SH-BCU-66

CADDY NO. 1398 ITEM NO. 12

JOB: UNIVERSITY HOSPITAL OF CLEVELAND
LOC: CLEVELAND, OHIO
CUST:
CUST#:

DWG# D-1-1398 SHT 1 OF 7

FIELD WIRING REQUIREMENTS FOR THE
UVC HOOD EQUIPMENT

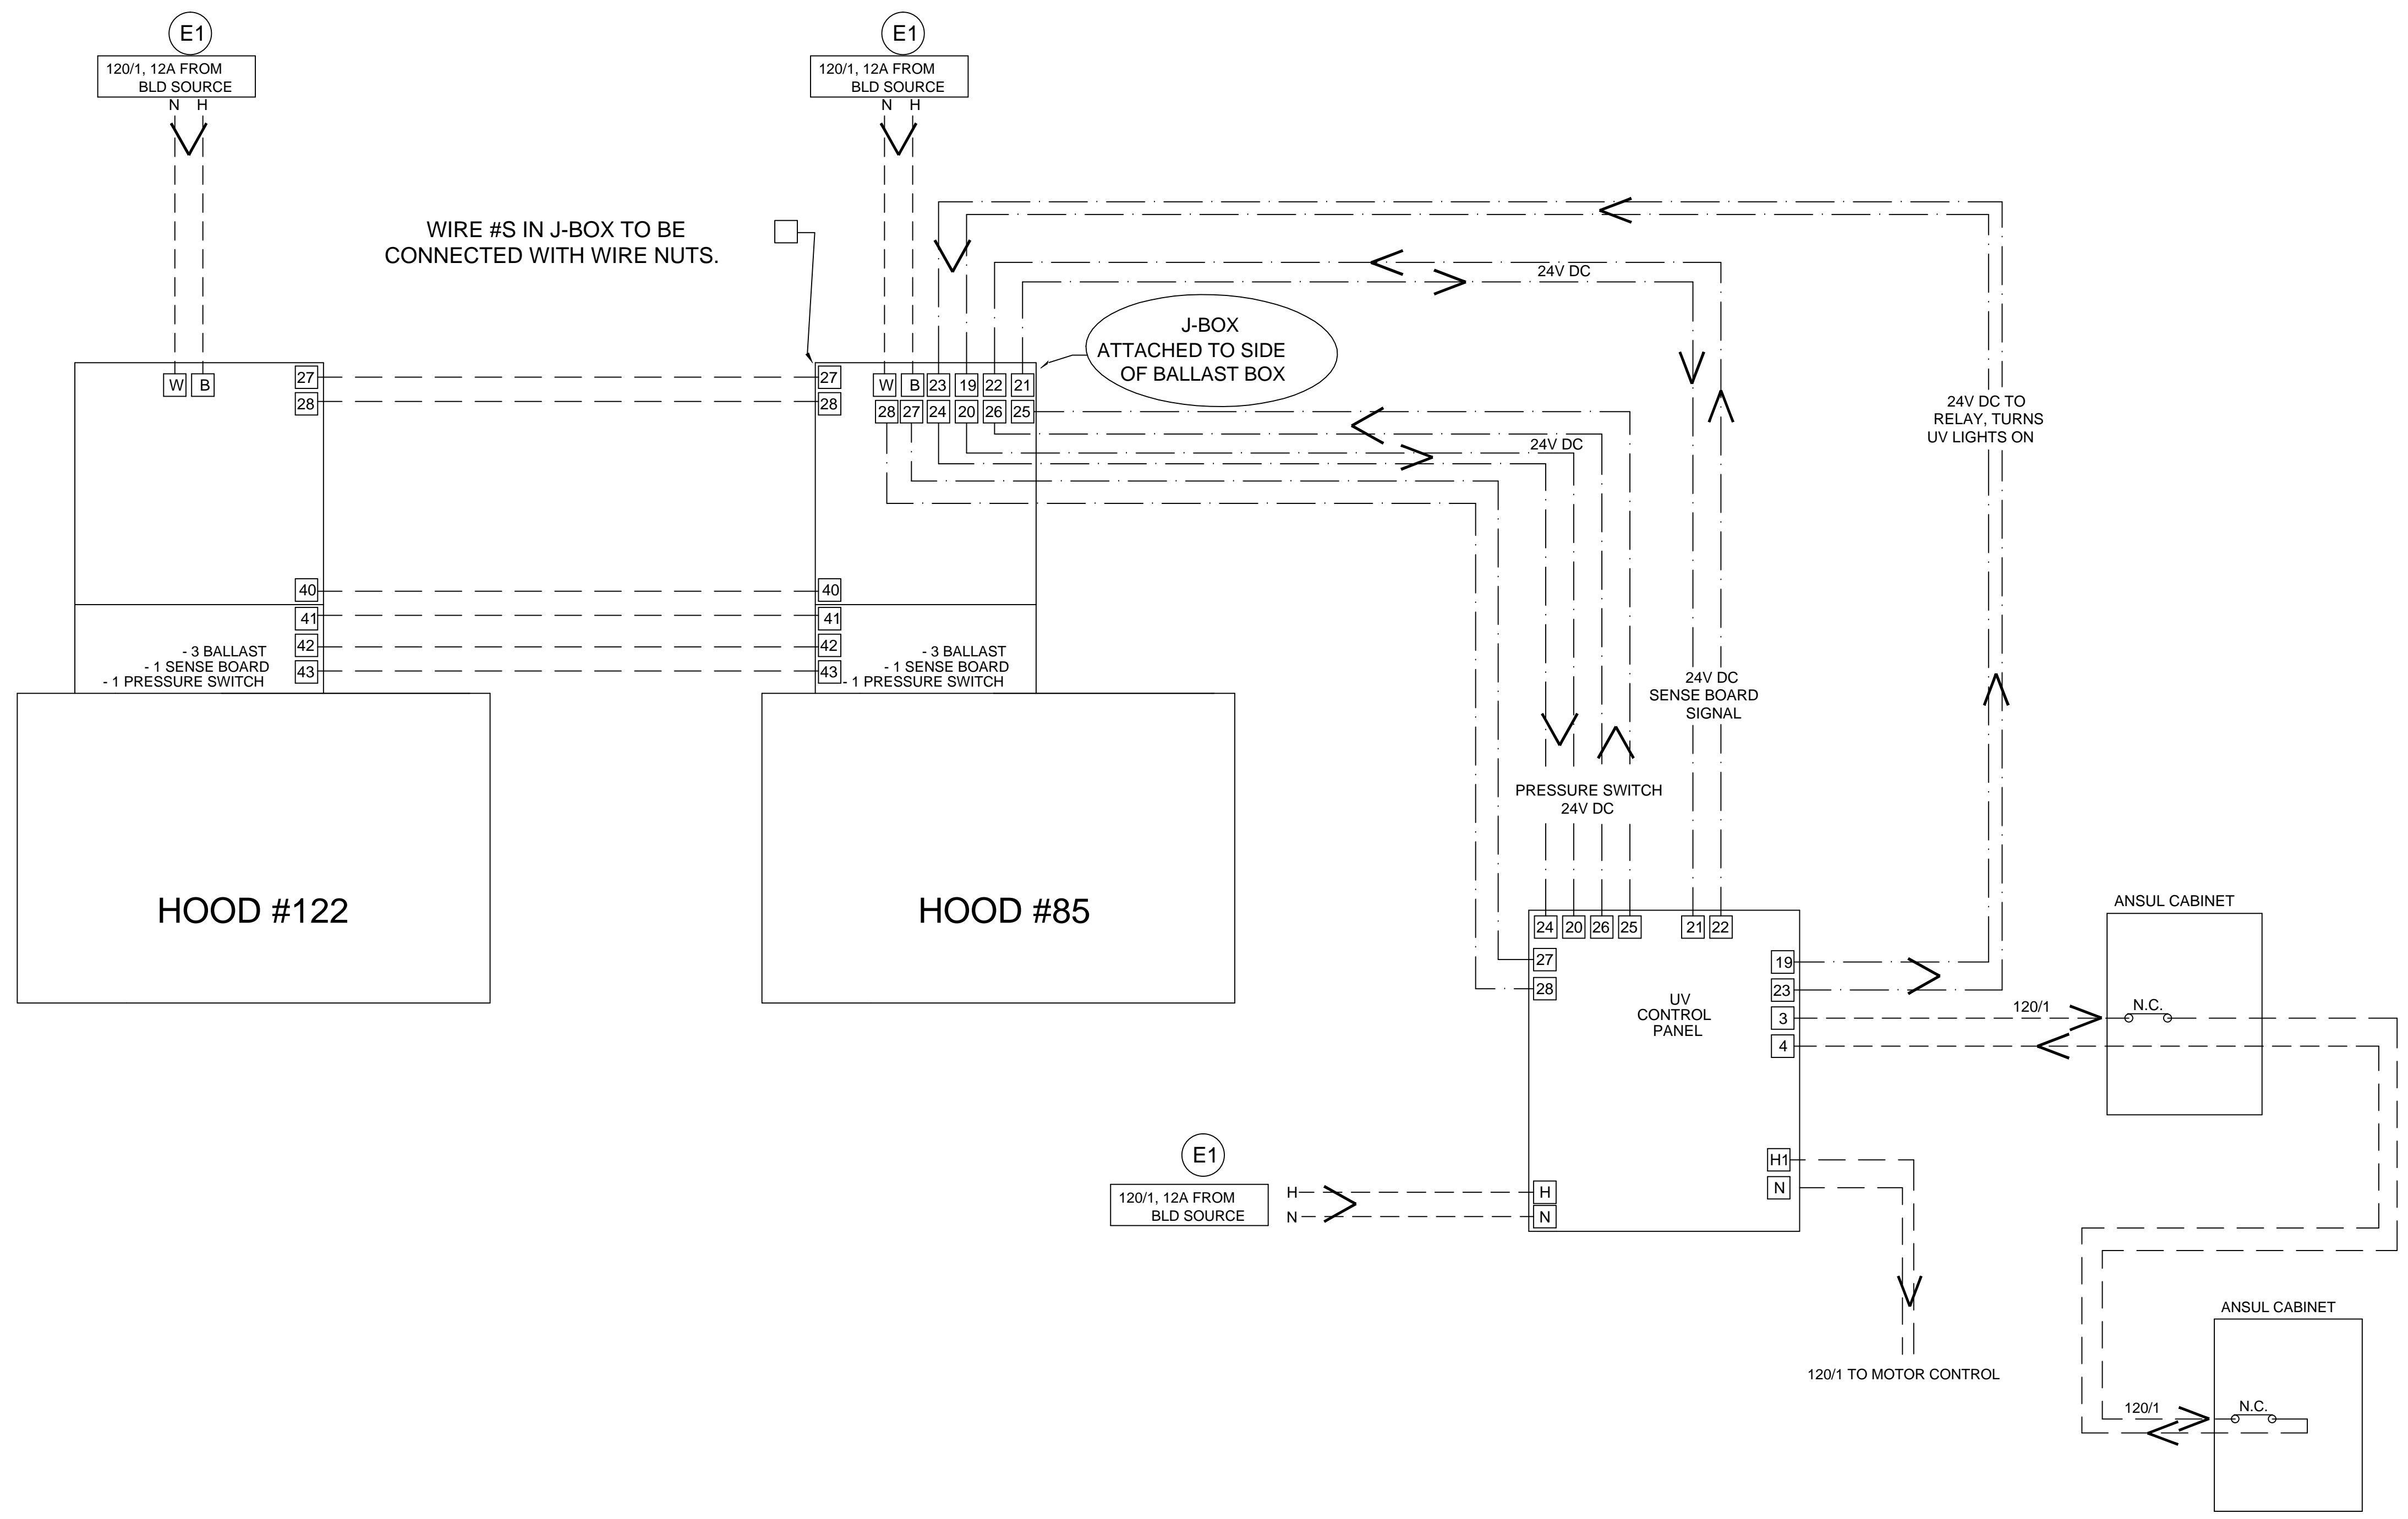
REVISIONS			
REV	DATE	BY	REMARKS
A	9-24-04	SWL	REVISED PER PHONE CONVERSATION WITH PAUL BERINSKY OF HAKAK ON 09/24/04. REMOVED ITEM #69 VENTILATOR FROM THIS UV CONTROL PANEL.
B	9-28-04	SWL	FABRICATED PER APPROVED DRAWING FROM PAUL BERINSKY OF HAKAK ON 09/27/04. EXHAUST FAN MOTOR CONTROLS BY OTHERS.
C	10-8-04	SWL	ADDED UPDATED FIELD WIRING
D	11-29-04	SWL	UPDATED FIELD WIRING DIAGRAM
